UNTIL SUCH TIME AS THESE DRAWINGS ARE APPROVED BY THE APPROPRIATE REVIEWING AGENCIES, JR ENGINEERING APPROVES THEIR USE. OFFICES DESIGNATED BY WRITTEN AUTHORIZATION. PREPARED FOR SR LAND, LLC 20 BOULDER CRESCENT SUITE 201 COLORADO SPRINGS, CO 80903 JAMES F. MORLEY (719) 471-1742	
J.R. ENGINEERING A Westman Company Centennial 300-740-9888 • Colorado Springs 719-583-2583 Fort Collins 970-491-9888 • www.jrengineering.com	
BY	DATE
No.	REVISION
H-SCALE	1"=50'
V-SCALE	1"=5'
DATE	07/17/23
DESIGNED BY	CWC
DRAWN BY	DUG
CHECKED BY	
VOLLMER ROAD (BARBARICK) -INTERIM CONDITION INITIAL/INTERIM GESC	
SHEET	2 OF 6
JOB NO.	25188.01

VOLLMER ROAD (BARBARICK)
 -INTERIM CONDITION
 FINAL GESC

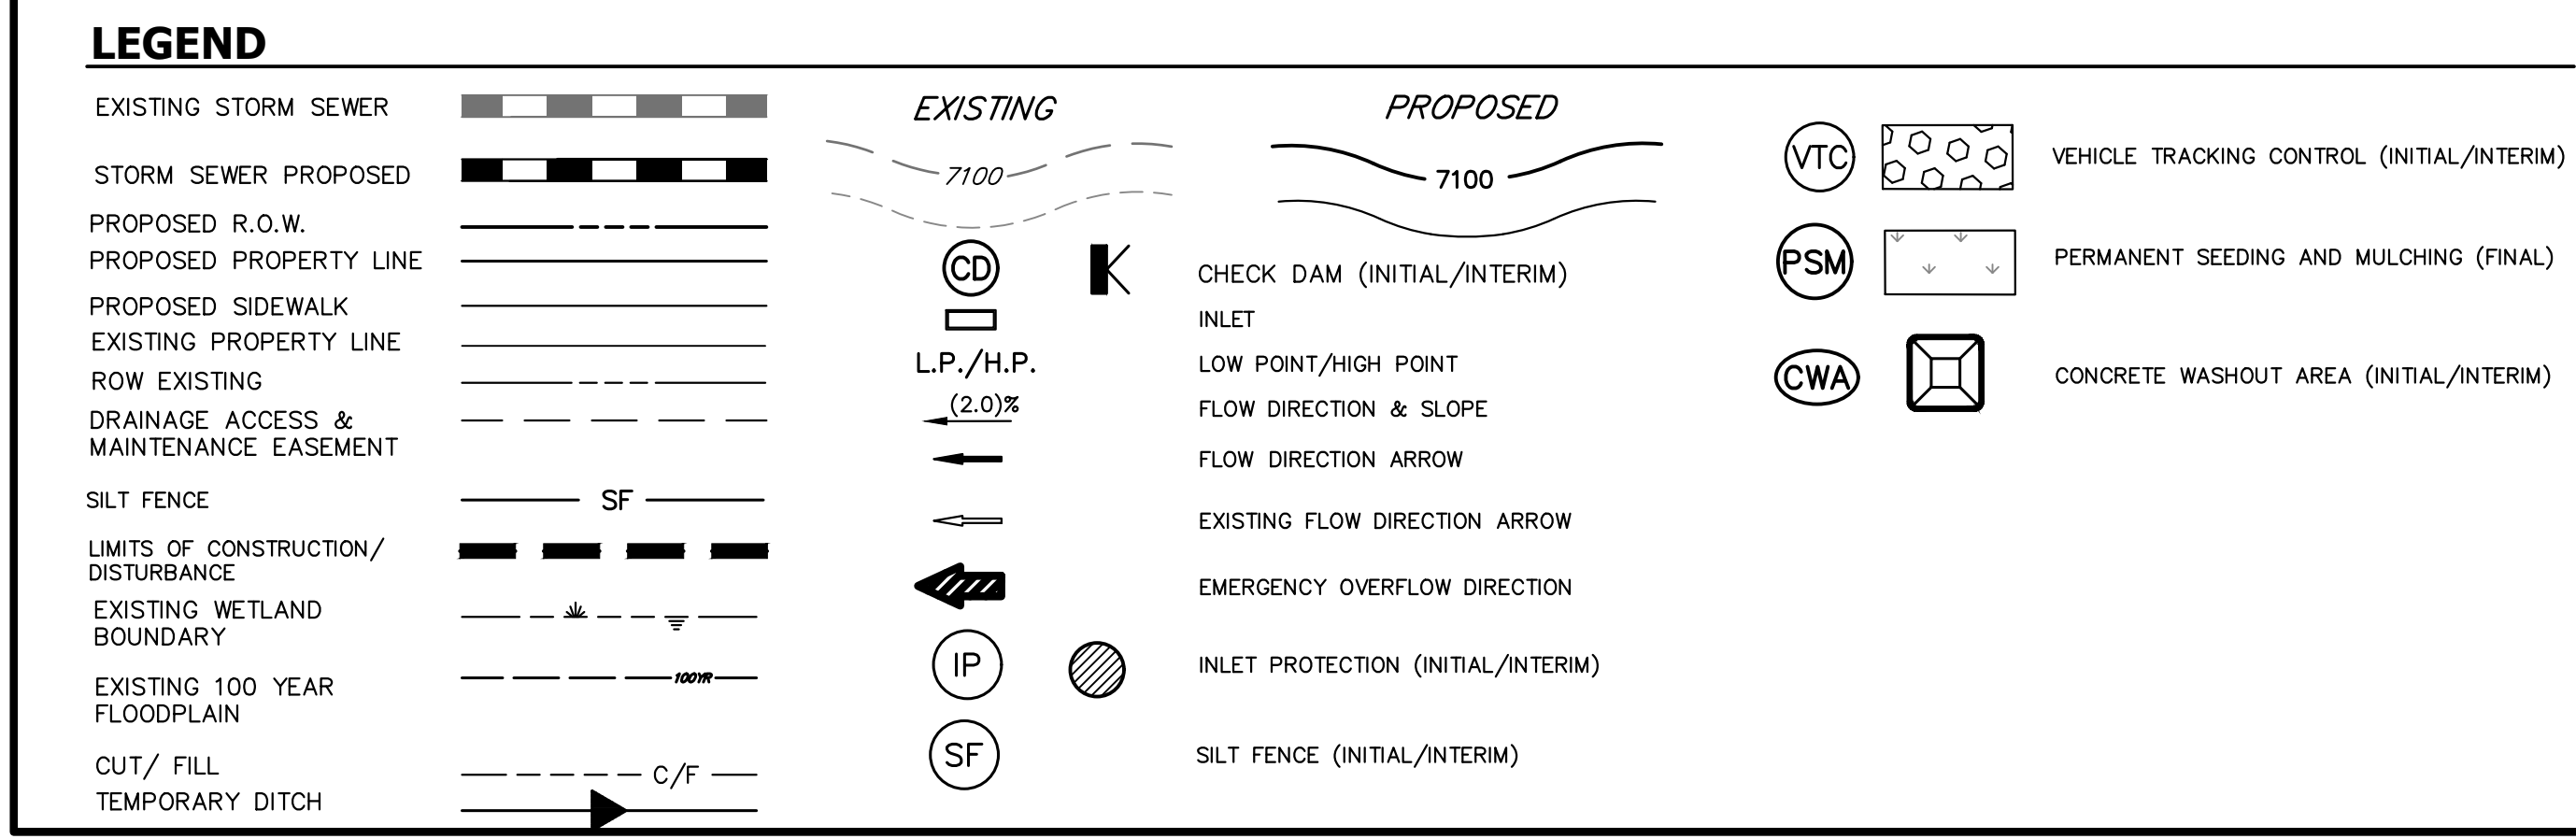
Show easements for off-site grading. Typical comment for all areas that exceed existing R/W and are outside the delineated 10' TG&CE

BMPs should not be outside the limits of construction/disturbance. Adjust LOC limits

GEC Checklist Item g: Show all existing utilities. If no utilities are present add a note to that effect.

JR Response: easements updated for grading and check dams

JR Response: Addressed, LOC updated

JR Response: Existing gas line shown, note added to plans
